NEWMAR CORPORATION

RECALL SERVICE BULLETIN

Newmar Corporation has decided that a defect relating to motor vehicle safety exists in specific motorhomes. NHTSA 18V 387 TC 2018-303

H.D. WIPER ARM REMOVAL AND INSTALLATION

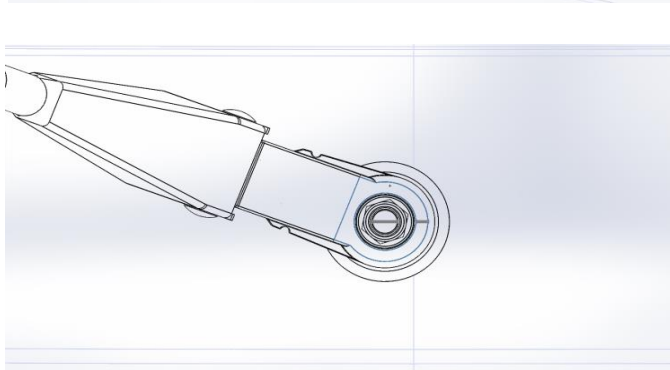
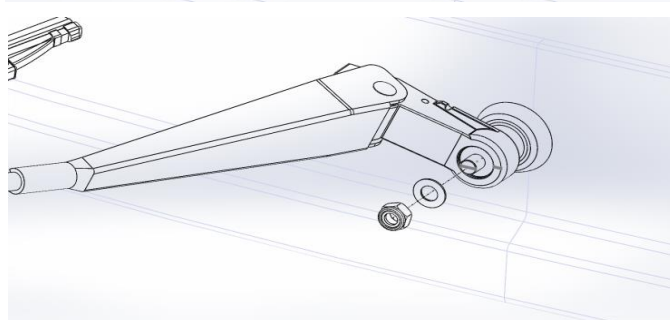
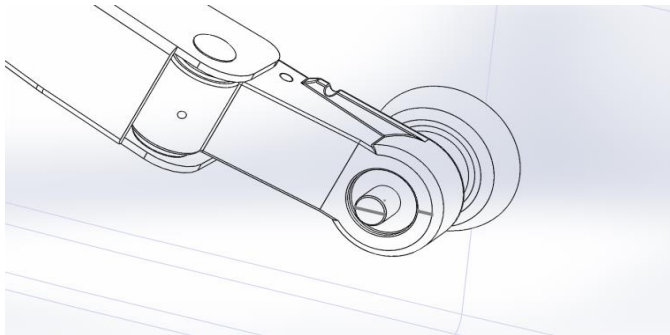
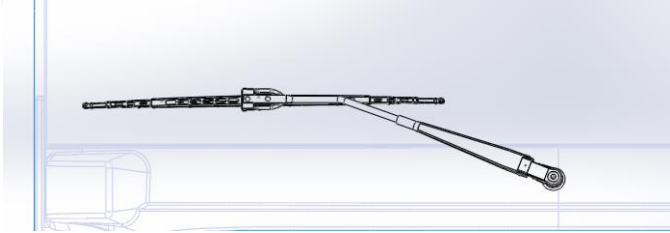
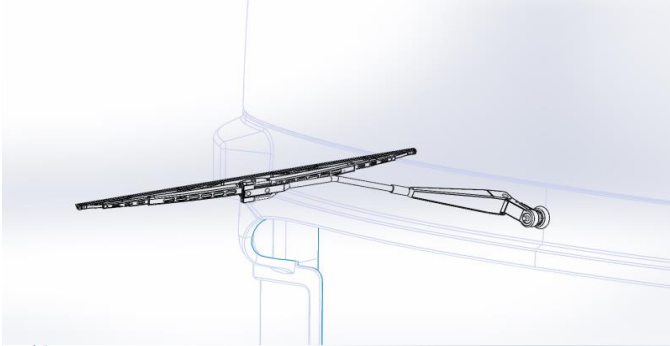
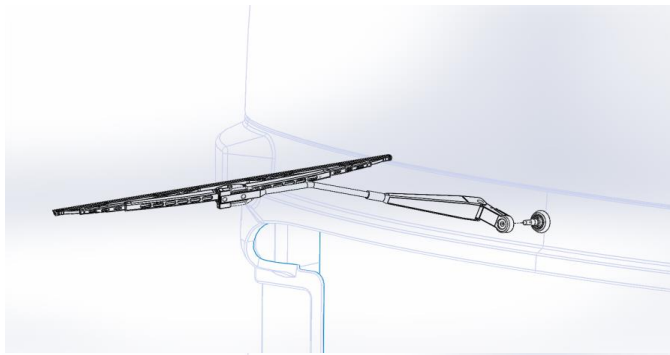
Issue: On certain motorhomes, the windshield wiper arms may have been manufactured incorrectly. This may reduce the driver's visibility under certain conditions and increase the risk of a crash and/or property damage.

Correction: Dealers will replace the wiper arms.

1. Make sure the Wiper System is in the Park Position where the Wiper Blades are parallel with the bottom of the windshield.
2. Remove the Wiper Arm Head Cover exposing the 12mm Locking Nut and flat washer.

3. Loosen the 12mm Locking Nut where the end of the Locking nut is approximately 1/8" past the end of the pivot shaft. Using a 2 Jaw Puller of the appropriate size position the jaws of the puller underneath the base of the Wiper Arm Head and position the Center Bolt of the puller where the end of the Center Bolt is centered inside the 12mm Locking Nut. Unseat the Wiper Arm Head from the Pivot Shaft.

4. Remove the 12mm Locking Nut and Flat Washer and discard. Move the Wiper Arm into the Lock-Back Position.
5. Remove the Wiper Arm Assembly from the Pivot shaft and Uninstall the Wiper Blade from the Wiper Arm. Discard the Old Wiper Arm.

6. Inspect the splines on the Pivot Shaft to insure the splines are free of any debris of the Wiper Arm Head. Clean splines if necessary.

7. Install Wiper Blade onto the New Wiper Arm. Make sure the Wiper Blade rotates freely when secured to the Wiper Arm saddle.

8. Position the Wiper Arm into the Lock-Back Position.
